Planning Department Staff Analysis

N6. Case No: A-26-1248106

Project Name: 211 S Howard Street - Townhome Development

Requests: Variance request from Section 27-5.4.5 and the landscape strip requirements of the DeKalb County Zoning Ordinance to:

SITE PLAN

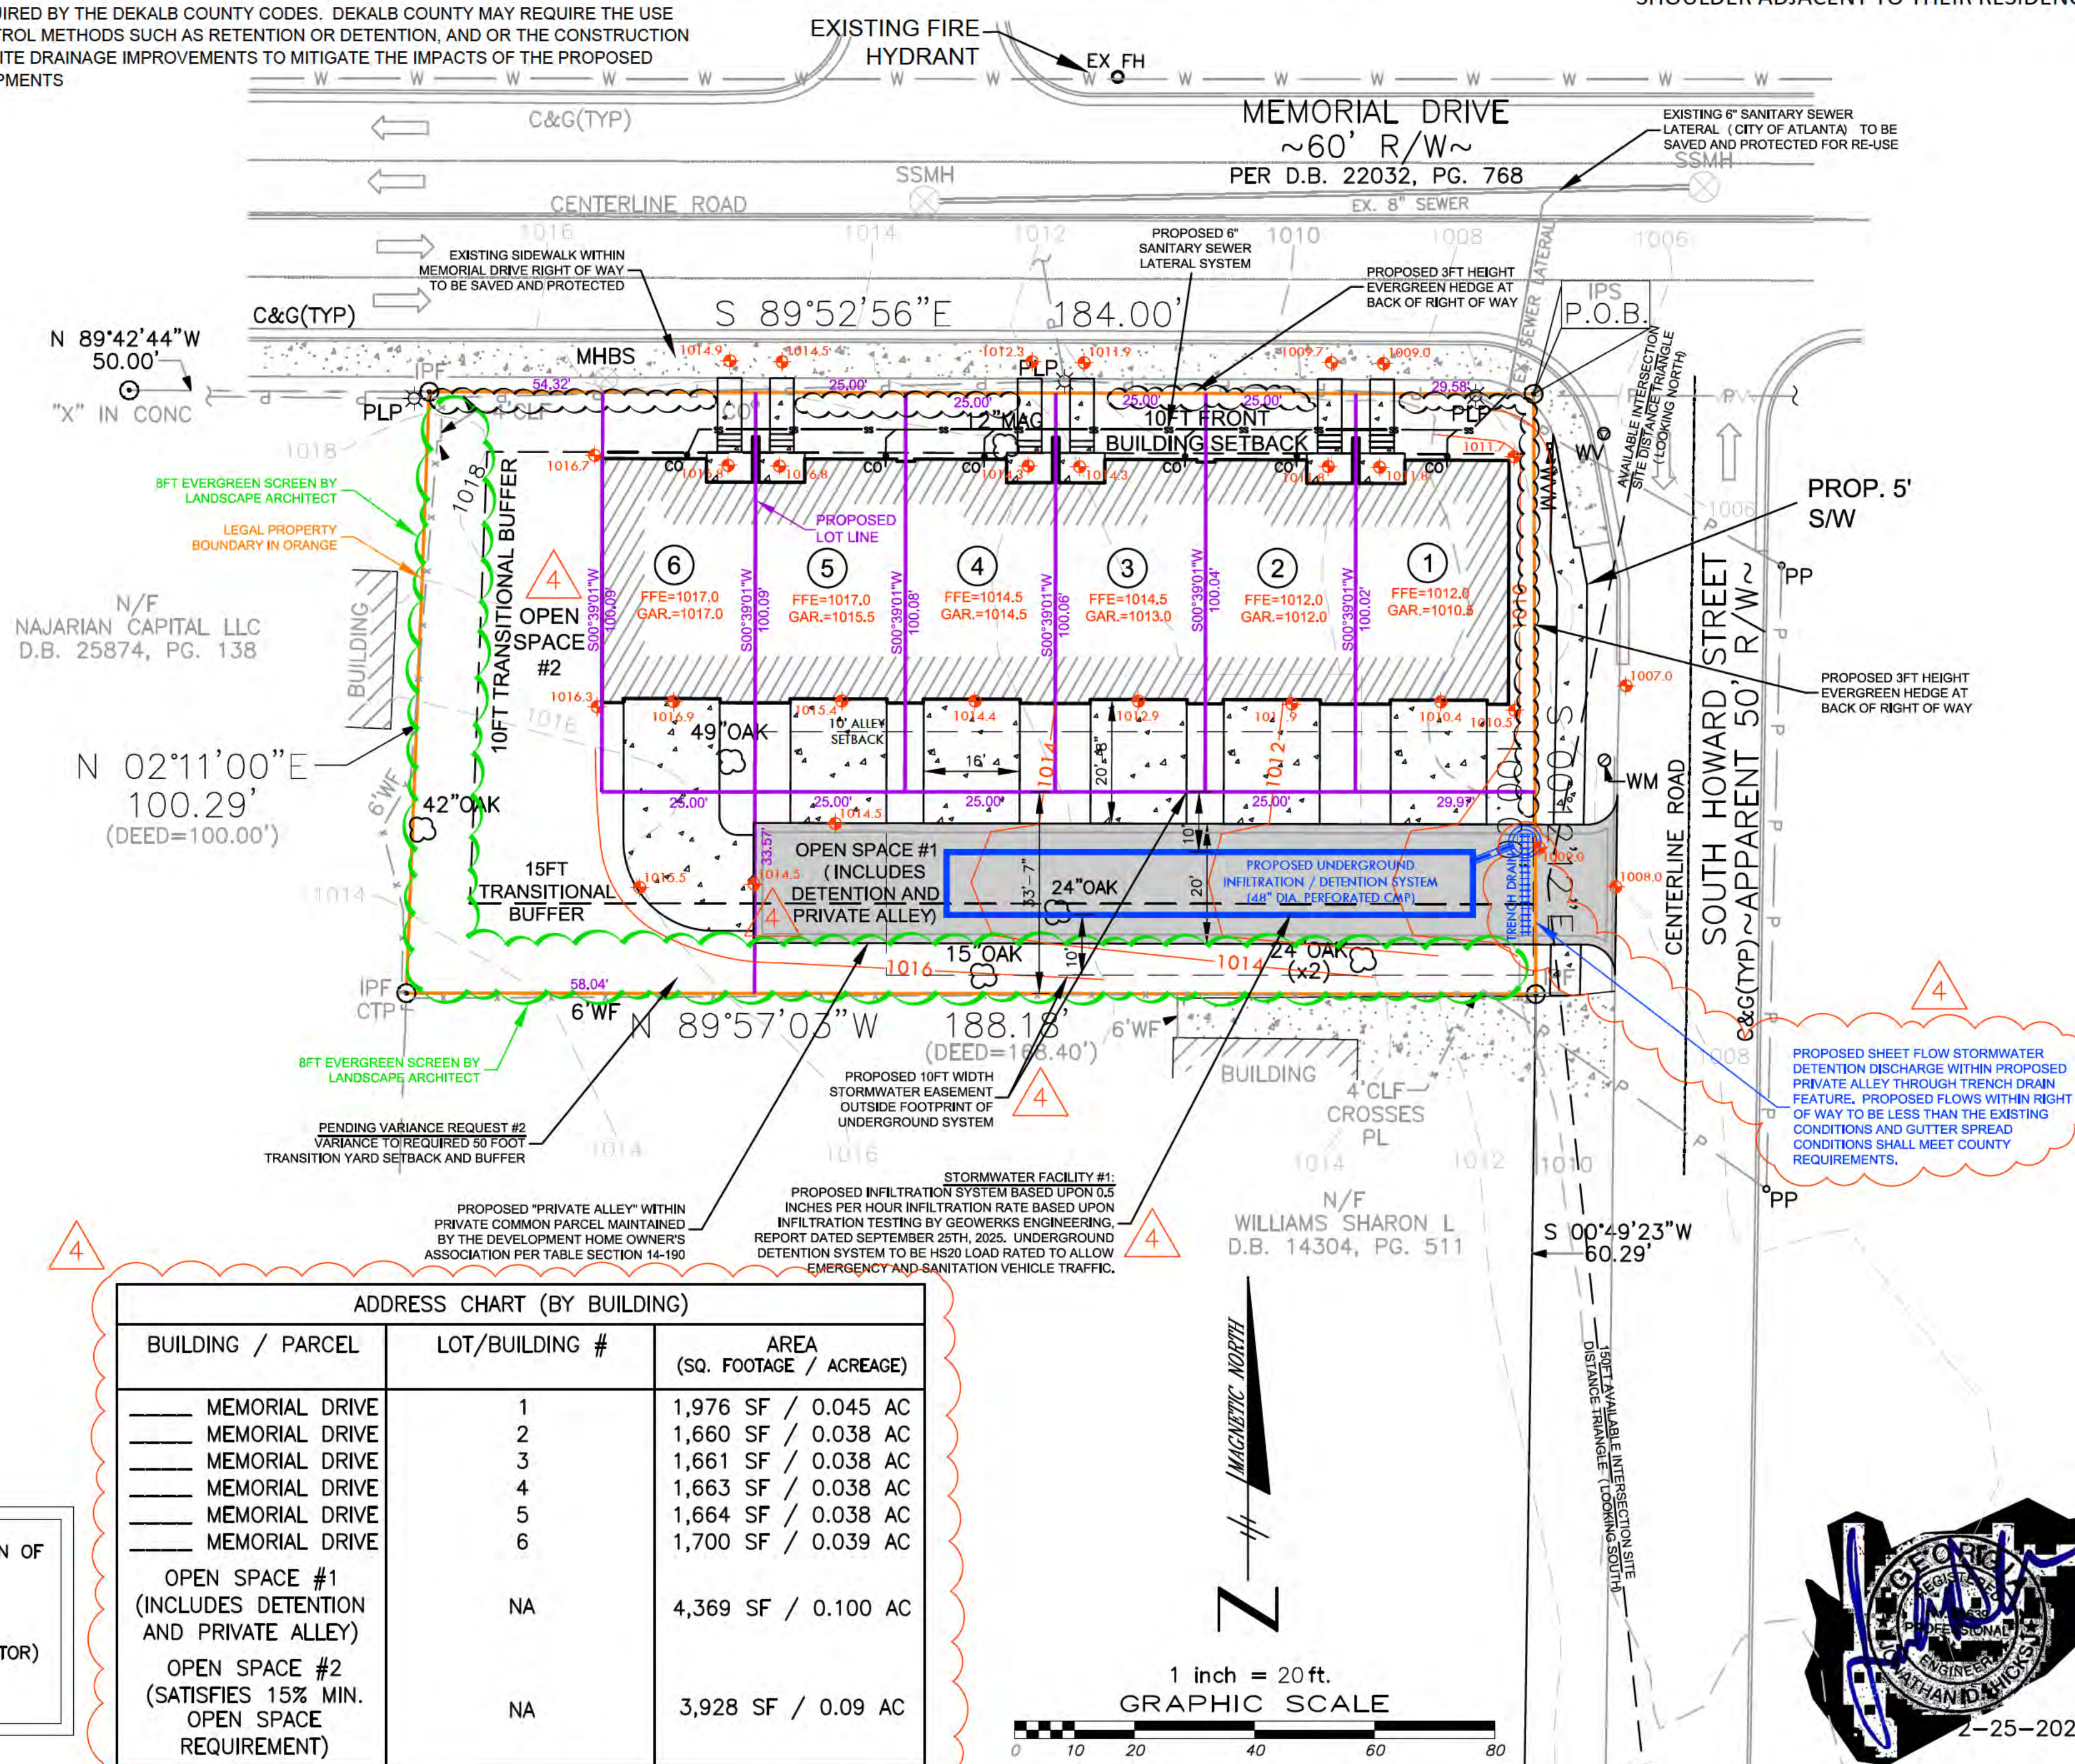
The applicant proposes to redevelop the property located at 211 S Howard Street for a residential townhome development. The submitted site plan shows six attached residential units, a private rear service alley, open space areas, proposed stormwater infrastructure, and proposed lot lines for the individual units. The property is located at the southwest corner of Memorial Drive and South Howard Street and contains approximately 0.427 acres.

the submitted request appears to go beyond the minimum necessary to afford relief. Staff further acknowledges that strict application of 50-foot buffers along both affected sides of the property would be heavily imposing on a constrained corner-lot site and that some reduction may be necessary to allow reasonable use of the property. However, there may be an opportunity to reduce the extent of the requested variances by reducing the number of proposed units, modifying the site layout, or otherwise revising the development program to better fit the dimensional limitations of the property.

However, the submitted request appears to exceed the minimum relief necessary. While the site may warrant some variance relief, the scale of the requested variances indicate that the proposed development may be over-programmed for the lot. There may be an opportunity to reduce the requested relief through a reduced number of units, revised site design, or a development program that better responds to the property's constraints and the adjacent R-75 single-family residential context.
